## Proposal for amendments to UN Regulation No. 13 (Braking)

This proposal aims to equip critical N3 vehicles with 4 axles over 25t of Electronic Stability Control systems due to their specific use creating potential stability troubles. This text proposes to revise wording of § 5.2.1.32. in order to cover these specific applications. The additions and deletions are shown in bold text to facilitate identification of these proposed changes within the existing Regulation.

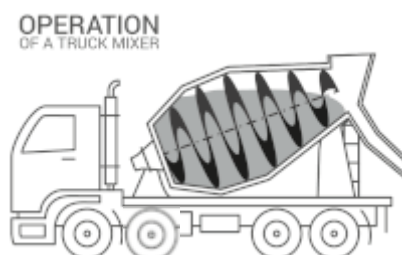
(c) N3 <sup>12/</sup> with 4 axles, **neither** with a maximum mass not exceeding 25t and a maximum wheel diameter code not exceeding 19.5 **or maintaining transported material’s state through continuous movement (concrete mixer truck for example).**

Specific N3 vehicles, carrying materials maintained in a continuous movement, as concrete mixer truck for example, are unstable when loaded, because their centre of gravity is not static, higher and not centered, as a result of the continuous rotative movement of the spinner, which carries the concrete to the side.
